Service Alert

Subject: TRANSMISSION DESIGN CHANGE (PART SUPERSESSION)	Service Alert No.: SA-002/24
	Last Issued : 10/23/2024

2025 CX-70 (H3T)

2024-2025 CX-90 (H3T)

Original Design (Transmission Hole Drilled)

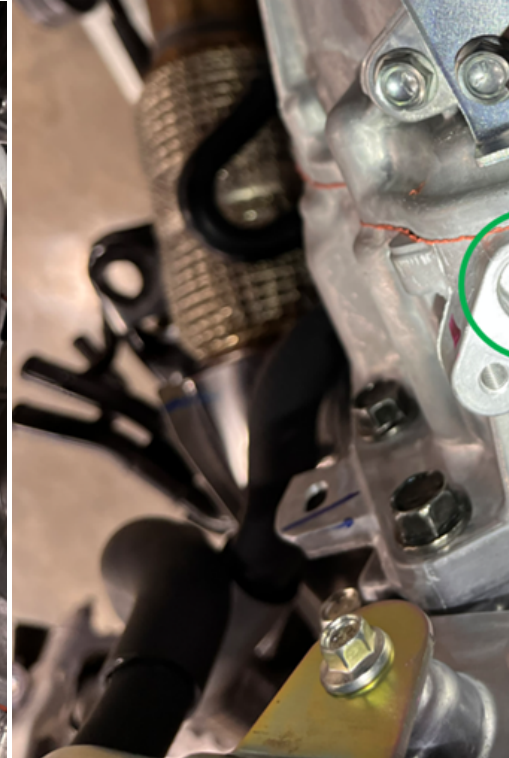
Due to a manufacturing change, the CX-70/CX-90 transmission has undergone a transmission part design change when replacing the transmission assembly.

Old design originally required a coolant line running to the top of the bell housing, the new design has omitted the hole and need for the coolant line.

The new/superseded design can be used in place of the old/original design and the coolant hose is no longer needed to be used.
